ZONING CHANGE REVIEW SHEET

CASE: C814-2012-0160
211 South Lamar PUD

ADDRESS: 211 South Lamar Boulevard

LAND USE PLAN

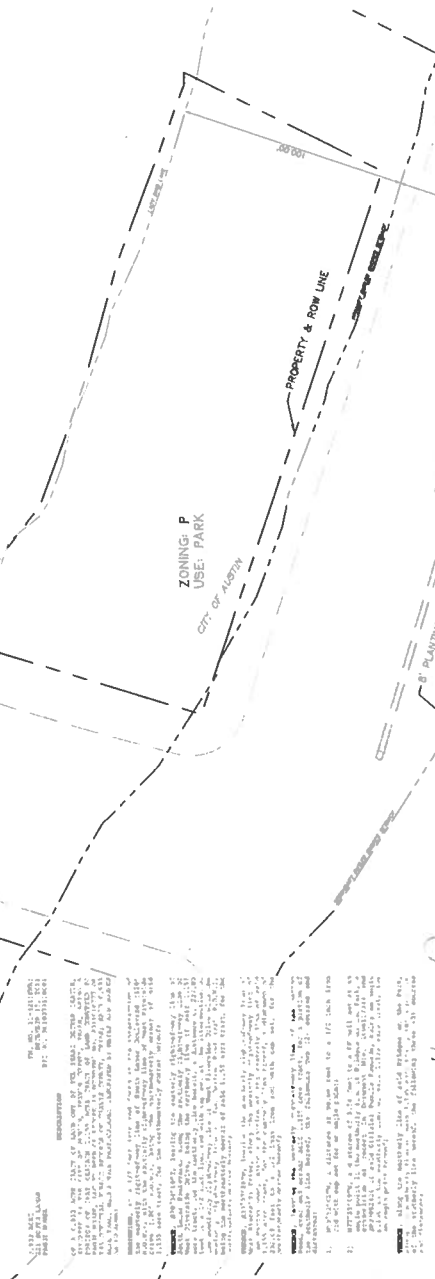
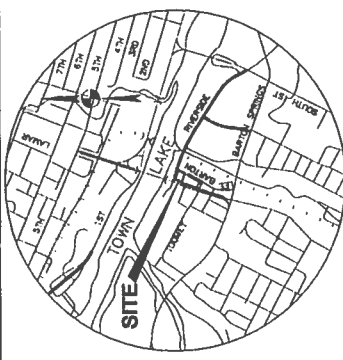
- 3. Land Use Plan Comments – Sheet 1**
 - a. Please clearly distinguish existing versus proposed land use; separate schematics on the same sheet would be ideal. Clearly depict PUD boundary (heavier line) and future building lines. What's the buildable area? Is there a setback from the Bridges building? Please label Paggi House and Bridges buildings as existing. Identify Fast Food Restaurant as Existing.**

- i. **The Land Use Plan has been revised to remove color depictions and is now black-and-white.**
4. Land Use Plan Comments – Sheet 2
- a. As noted above, please be consistent with items noted in the Tier Tables. If something is specified, quantified, qualified, or otherwise elaborated upon in one, please do so in the other. Note: Some of these plan notes may be incorporated into the PUD document instead of, or in addition to, being on the plan sheet. Specificity matters.

ENV. TREE
PUD EXHIBIT

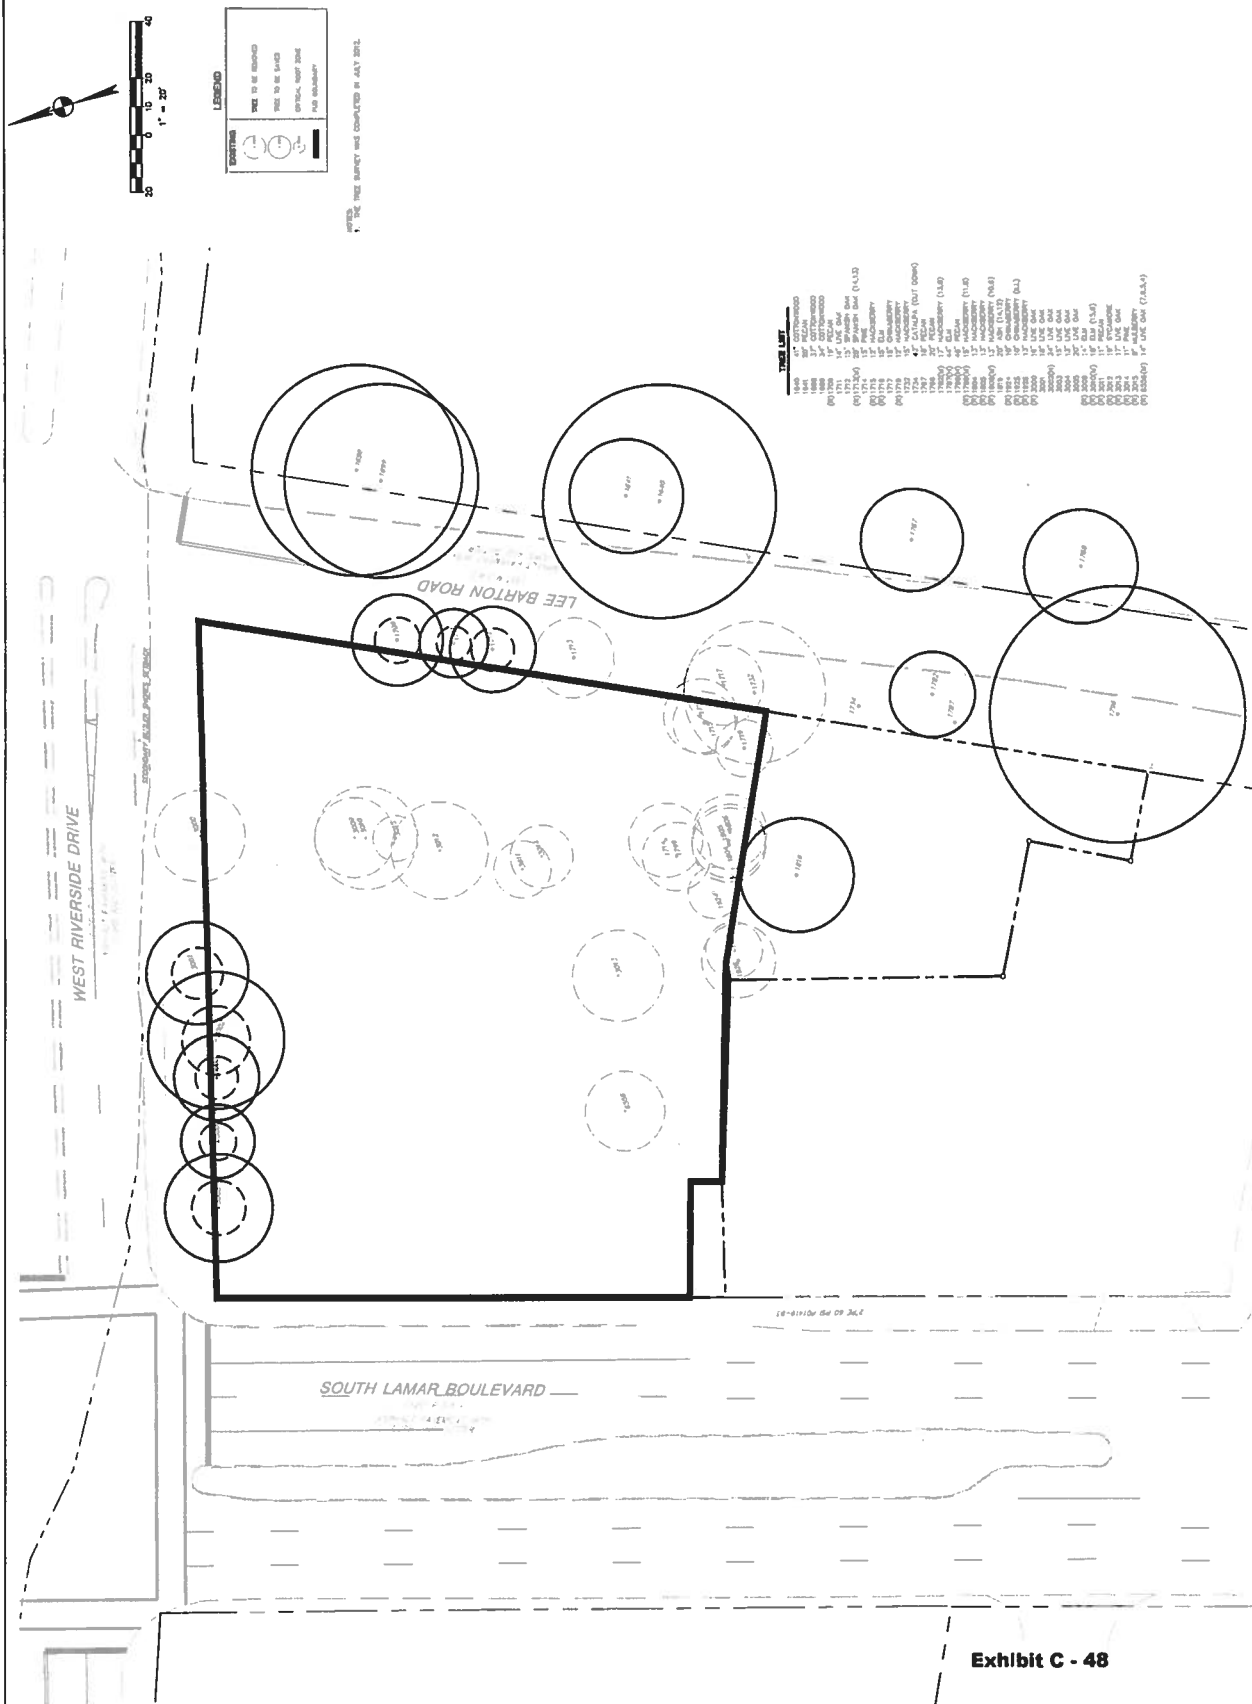
UPDATE #1 Note # 32 addresses the tree preservation criteria required to preserve trees in the PUD. The Env. Tree PUD Exhibit, sheet 4, shows tree #1709 to be removed in the list when it is supposed to remain, and it shows tree 1732 with a 50 ft CRZ instead of a 30 ft CRZ as stated in the tree survey list. Please correct these inconsistencies. This comment can be cleared informally.
